RENESAS TECHNICAL UPDATE

Product Category	MPU/MCU	Document No.	TN-V85-A007A/E	Rev.	1.00
Title	Precaution of A/D conversion accuracy		Information Category	Technical Notification	
Applicable Product	V850E2/Fx4-H series	Lot No.	Reference Document	User Manual of each product	
	V850E2/Fx4 series V850E2/FF4-M V850E2/Px4 series

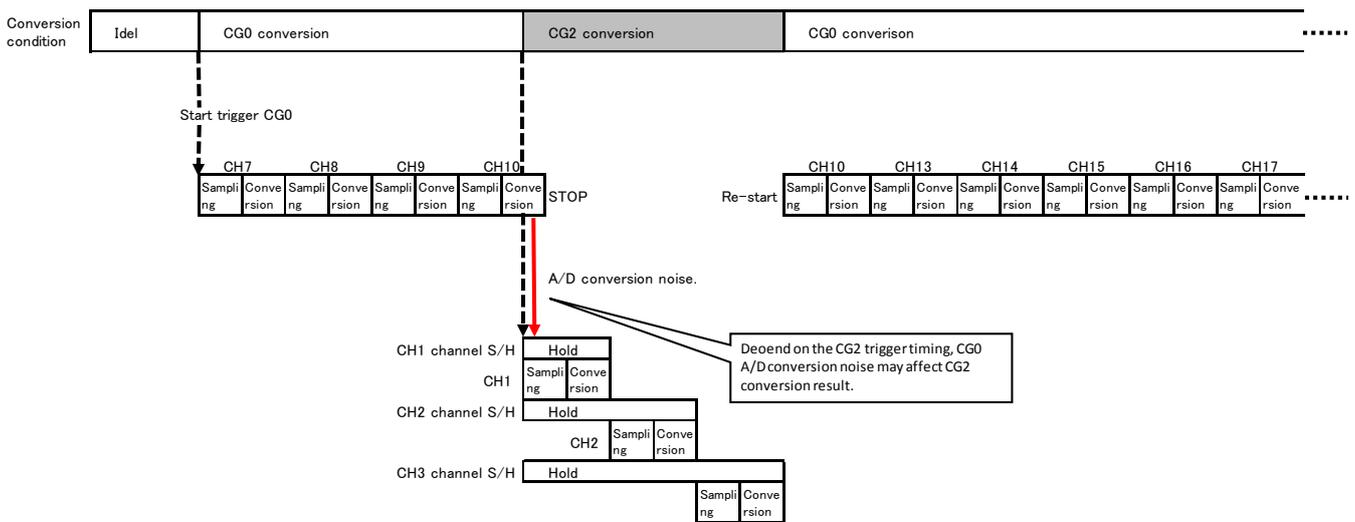
1. Restriction

There is a possibility that A/D conversion accuracy of high priority CG become worse when following both condition is used.

- 1) During the A/D conversion of low priority CG (e.g. CG0), conversion trigger of the high priority CG (e.g. CG2) occur.
- 2) The channel S/H function of high priority CG (e.g. CG2) is enabled.

Note: The above case is one of an example of CG combination. The CG priority is CG2 > CG1 > CG0.

CG0(Low priority) = CH7, CH8, CH9, CH10, CH13, CH14, CH15, CH16 (Continuous conversion mode.)
 CG2(High priority) = CH1, CH2, CH3 (Channel S/H function is enabled.)

Note: The fluctuation of conversion error depends on the external circuit and devices mounted on the customer board.

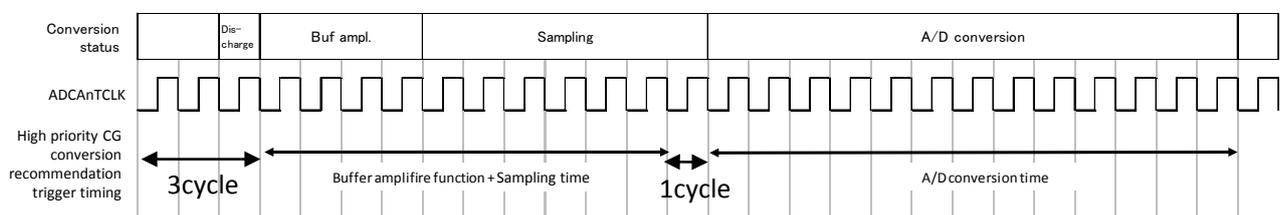
2. Countermeasure

- 1) Low priority CG (e.g. CG0) A/D conversion have to be finished 3 ADCAnTCLK before the conversion trigger of high priority CG (e.g. CG2), if the CG2 contains the channels which channel S/H is available.
- 2) If there is a case that high priority CG (e.g. CG2) conversion trigger occur during the conversion of low priority CG (e.g. CG0), disable the high priority CG channel S/H function.
- 3) If the both condition mentioned in previous page need to be used, adjust high priority CG (e.g. CG2) conversion trigger timing not to occur 3 cycle period before “buffer amplifier function + sampling time” and 1cycle period before “A/D conversion time”

Example condition: Discharge function: ON, Buffer amplifier function: ON, ADCAnCTL1.ADCAnCTYP=0

Note: Even if trigger timing is adjusted above recommendation time, conversion error specified in Data Sheet can't be removed.
